**AGENDA**  
**Glen Ellyn Architectural Appearance Commission**  
**Wednesday, April 12, 7:00 p.m.**  
Glen Ellyn Civic Center  
Galligan Board Room  
535 Duane Street

**TO:** Glen Ellyn Architectural Appearance Commission  
**FROM:** Martin Scott, Director of Community Development  
**FOR:** April 12, 2023 Public Meeting  
**SUBJECT:** 525 S. Park Blvd. – Exterior Appearance Approval

**REQUEST:** The petitioner is requesting an Exterior Appearance Review for the Willowbrook Wildlife Center located at 525 S. Park Blvd., including the renovation the existing propagation/research building, construction of a new clinic and visitor center, and a variety of outdoor rehabilitation enclosures. (Phase A is noted in the plans but was approved last year and is currently under construction. The buildings in this application are within phases B-D). In order to proceed with the project, the petitioner will need to receive approval of the Exterior Appearance of the project.

NEW CLINIC DESIGN  
ELEVATIONS - BUILDING MATERIALS

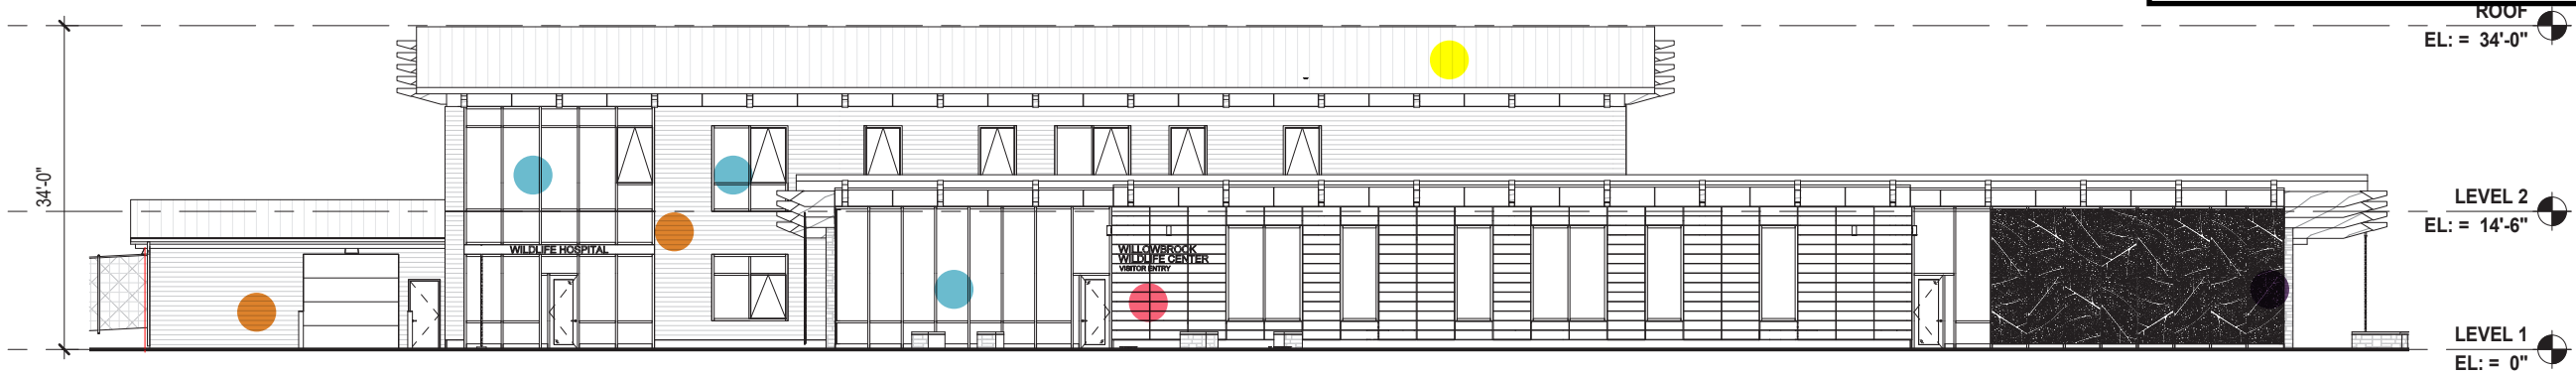
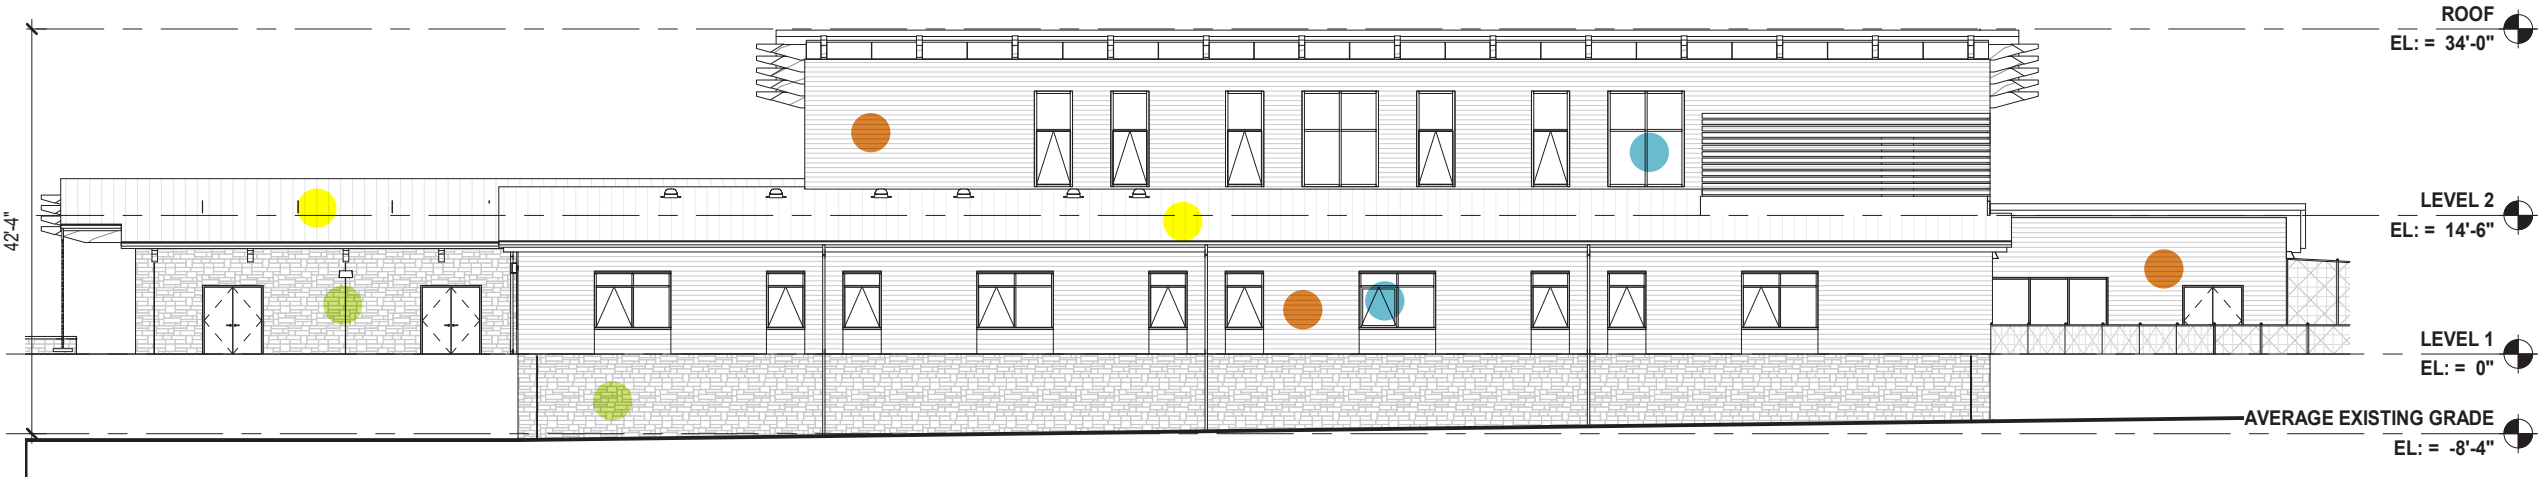
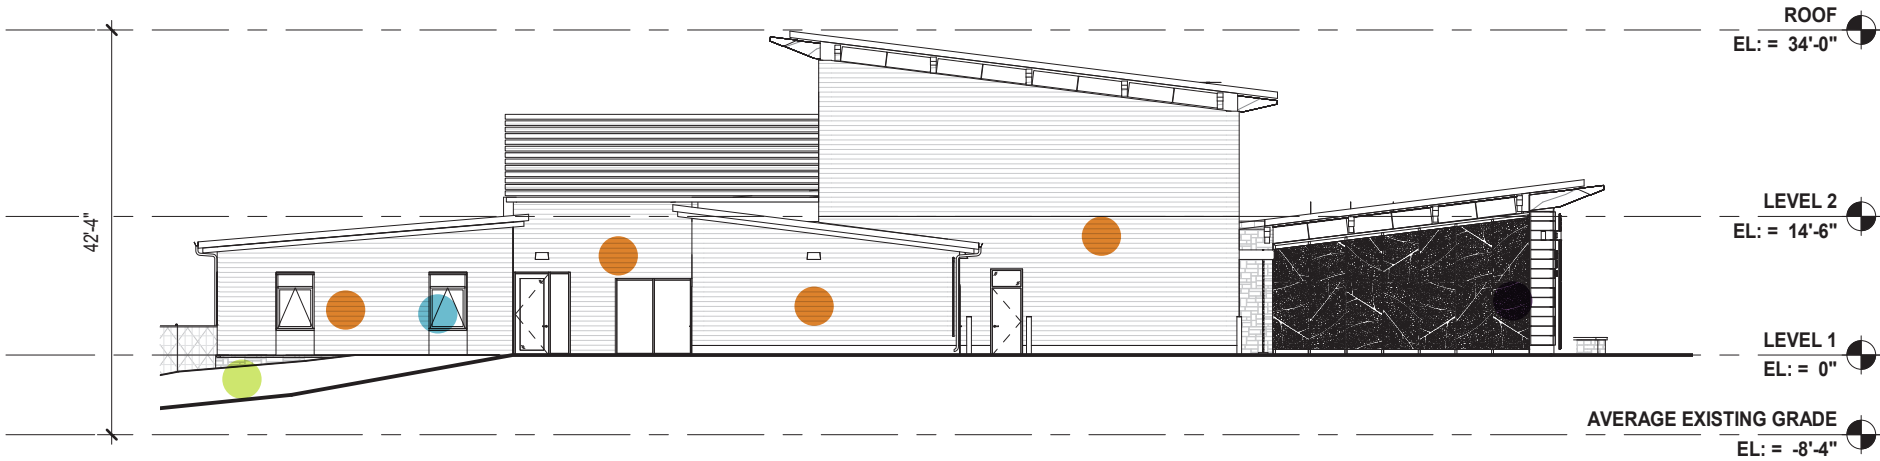
Section 1.2 of the Appearance Review Guidelines states, “Materials and finishes not recommended include...aluminum siding, trim or panel systems; glass storefront wall systems that extend to the ground.” The proposed storefront includes aluminum framing and panels, as well as the glass storefront portion that extends to the ground. Also, Section 3.3.3 of the Appearance Review Guidelines states, “windows and doors should be inset behind the plane of the wall, clearly defined by wood or masonry trim.” The AAC should consider the function and location of this building (and others) in regard to materials. It appears the materials were thoughtfully chosen as a consistent theme to fit a natural setting. The materials were also chosen not only to be attractive but also durable. This approach carries over into the existing building renovation materials and improvements such as the trash enclosure.

The clinic and visitor center walls, which extend to the ground and are constructed of glass or “leaf anatomy inspired” metal screens, also do not comply with Section 1.2 of the Guidelines. However, the AAC should consider that this type of design is common in nature centers, zoos, and similar facilities. In some cases, the design and use of materials may be functional, while at other times it is artistic and is part of the overall building program.
